CITY OF ROSEBURG PLANNING COMMISSION

**CITY OF ROSEBURG
PLANNING COMMISSION
REVISED STAFF REPORT**

To: Planning Commission
From: Mark Moffett, Associate Planner
Subject: Merle Avenue Subdivision & Variance Request

In the matter of an application by i.e. Engineering, Inc. for a 10-lot Subdivision with concurrent Variance to reduce right-of-way width from 60 to 40 feet on property located at 2240 NW Merle Avenue) Subdivision) File No. SUB-22-001) and concurrent) Variance) File No. V-23-002

PRELIMINARY PUBLIC RIGHT-OF-WAY LANDSCAPE PLAN

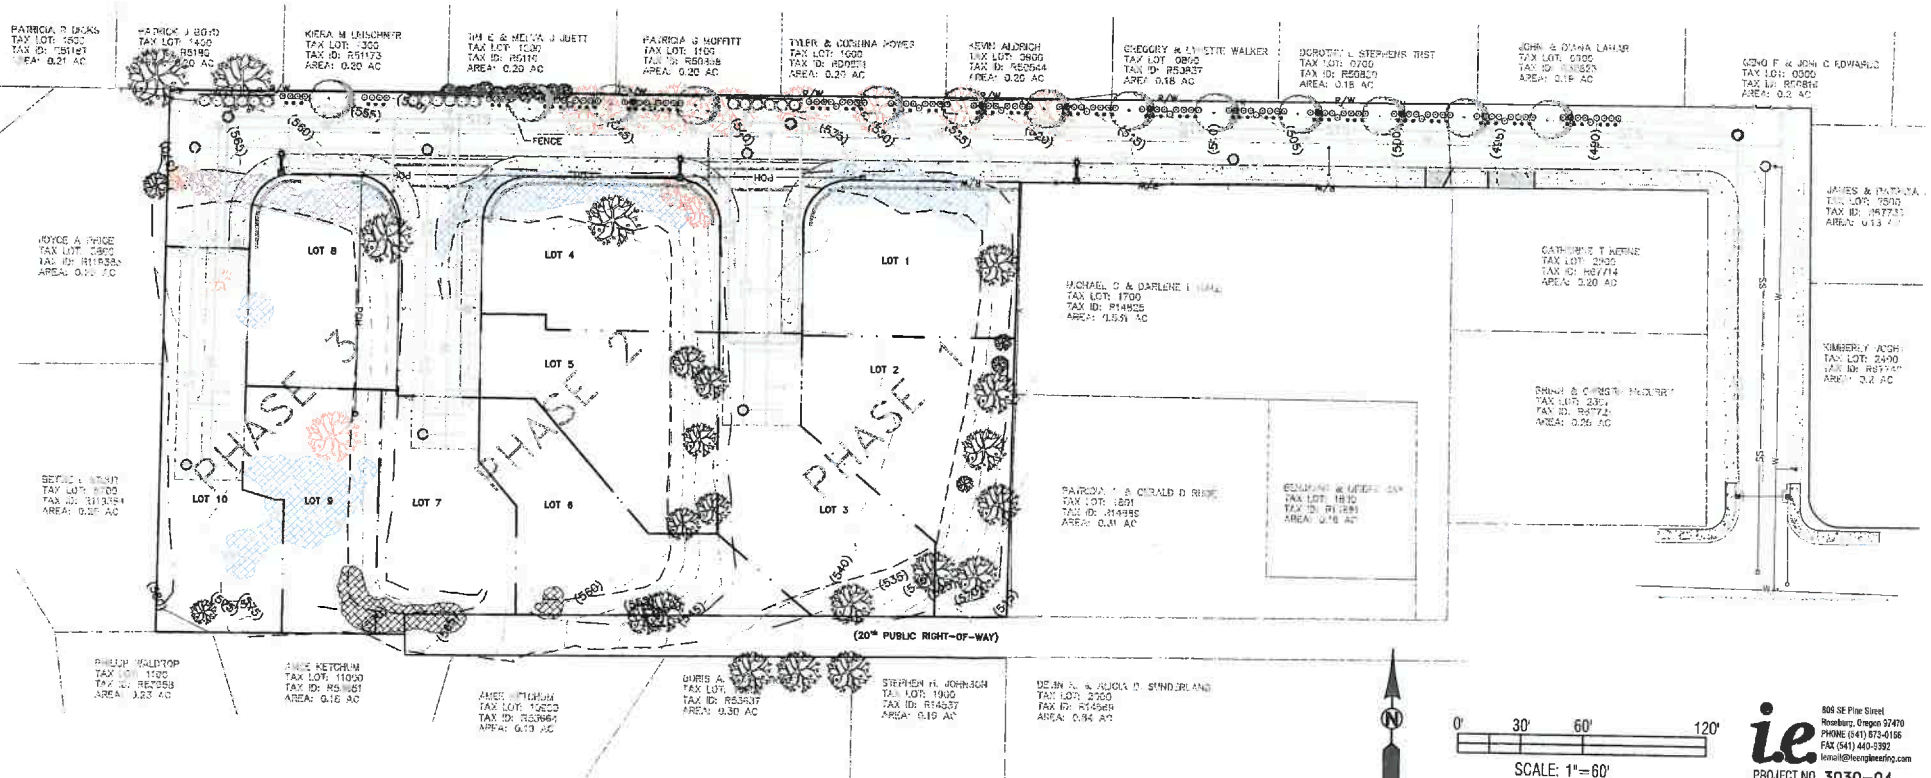
There are no specific requirements in the Roseburg Municipal Code for permanent landscape plantings in the public right-of-way, with the exception of a Prohibited Street Tree List. The area where trees are to be planted is on the sloping north side of the extended NW Merle right-of-way, where the land slopes downhill to the back fence line of properties fronting onto NW Canterbury Drive. In some locations below each of the three new L-shaped street intersections, segments of sight-obscuring fence materials behind a row of new shrub plantings are also shown.

While the plantings as proposed would provide significant screening and buffering of the new roadway to the abutting neighbors, addressing some of the privacy concerns raised in public testimony, there is no RMC standard or approval criterion that would require the plantings. In addition, during construction there may be unanticipated conditions or issues that prevent the planting from being installed. Therefore, in order to provide for the ability to install the plantings while also recognizing it is not required, a condition of approval is necessary as follows: “The preliminary landscape plan from the applicant dated February 24, 2023 is approved and encouraged by staff. Plantings shall be installed and maintained as proposed to the greatest extent possible, unless written documentation is provided for the original subdivision case file showing that plantings cannot be installed as proposed from a registered engineer, architect, or either the Public Works or Community Development Directors”.

8. The preliminary landscape plan from the applicant dated February 24, 2023 (Exhibit K.2) is approved and encouraged by staff. Plantings shall be installed and maintained as proposed to the greatest extent possible, unless written documentation is provided for the original subdivision case file showing that plantings cannot be installed as proposed from a registered engineer, architect, or either the Public Works or Community Development Directors.

PRELIMINARY SITE PLAN

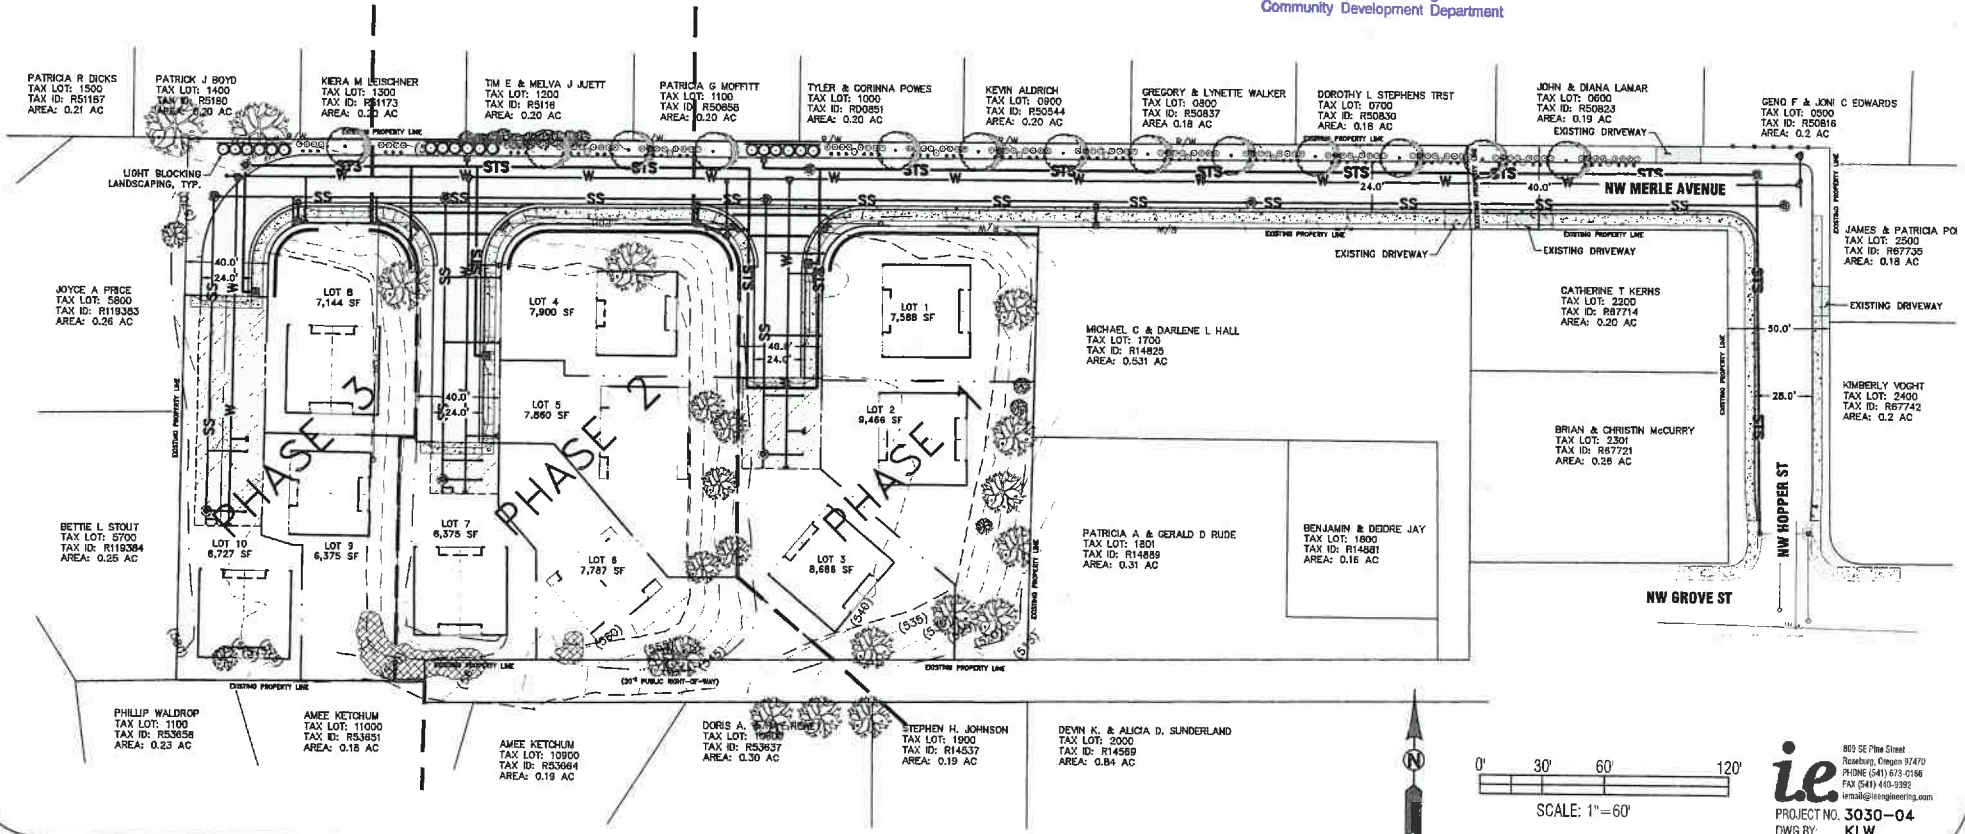
In the revised preliminary subdivision plan presented by the applicant on February 24, 2023, and in line with concerns and comments identified by staff in the February 14th, 2023 staff report, the proposal meets all lot size specifications from RMC Chapter 12.04. All proposed lots are at least 60 feet wide. All individual lots are at least 7,500 square feet, with the exception of lot 7 (6,375 sq. ft.), lot 8 (7,144 sq. ft.) and lot 9 (6,375 sq. ft.). Having up to 30% of the lots be smaller than 7,500 sq. ft. is allowed, because the average lot size (7,790 sq. ft.) exceeds the standard, and because no lot is less than 85% of the standard in the revised layout (all lots are at least 6,375 sq. ft.). *With regards to the lot width and size requirements, this criterion is met.*

In the revised preliminary subdivision plat map submitted by the applicant on February 24, 2023, the private driveway and access easements serving lots 2, 6 & 9 have been modified to extend directly up to the lots being served as required. *Therefore, this easement-related criterion is met.*

Staff Finding: In the revised preliminary subdivision plan presented by the applicant on February 24, 2023, and in line with concerns and comments identified by staff in the February 14th, 2023 staff report, the proposal meets all lot size specifications. All proposed lots are at least 60 feet wide and 80 feet deep. All individual lots are at least 7,500 square feet, with the exception of lot 7 (6,375 sq. ft.), lot 8 (7,144 sq. ft.) and lot 9 (6,375 sq. ft.). Having up to 30% of the lots be smaller than 7,500 sq. ft. is allowed, because the average lot size (7,790 sq. ft.) exceeds the standard, and because no lot is less than 85% of the standard in the revised layout (all lots are at least 6,375 sq. ft.). *This criterion is met.*

1. Approval is for the Property shown on the map submitted with the application. Preliminary Plat approval is granted based on the revised plan and layout dated February 24, 2023 (Exhibit K.3).

GEO TECH TEST PIT LOCATIONS

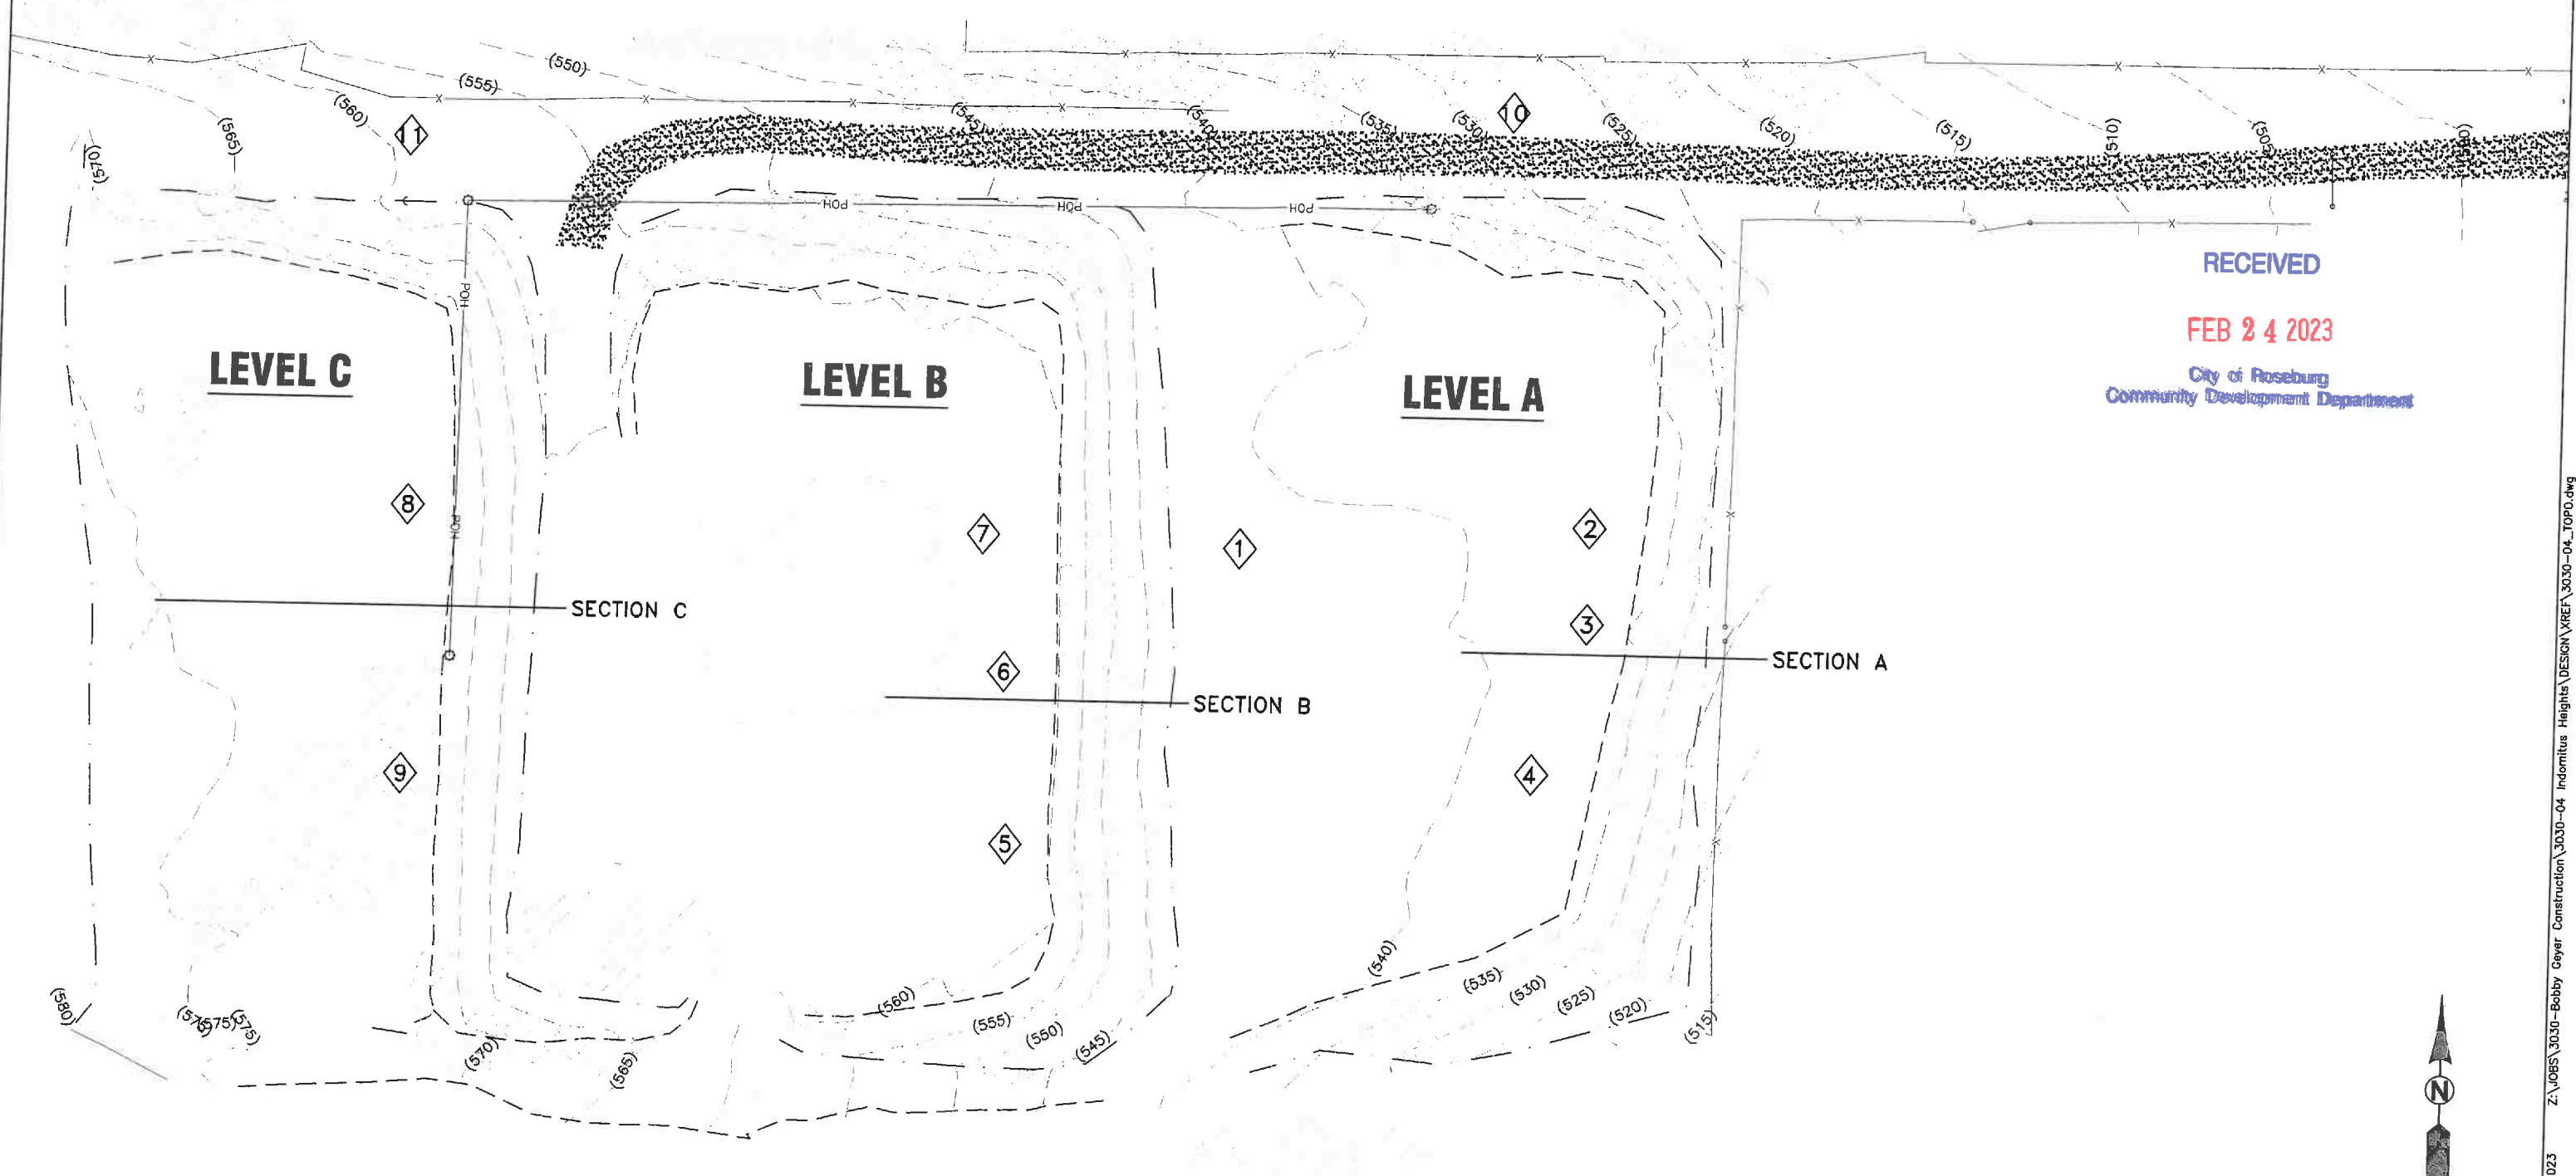
- Written recommendations on using plantings to stabilize slopes, and information on the proposed location, species and size of new planting materials, especially along the southern edge of the extended NW Merle right-of-way;
- A general Erosion Control plan and recommendations;
- Geotechnical consideration of the revised retaining wall locations on the south versus north side of extended NW Merle; and
- Locations for the 11 geotechnical soil investigation sites should be shown on a plan.

In their revised submittal on February 24th, 2023, the applicant provided all the above missing information (Exhibits K.1 through K.5). A detailed 5-page Erosion Control (1200-C) Plan was provided, along with a revised geotechnical report which included the missing information. Written recommendations and a detailed preliminary landscape plan was provided, showing a near-continuous row of new shrubs and trees along the north edge of extended NW Merle, with existing trees and shrubs to be removed also identified. Consideration was given to the revised retaining wall design and locations, and the missing soil investigation sites were shown on a site plan.
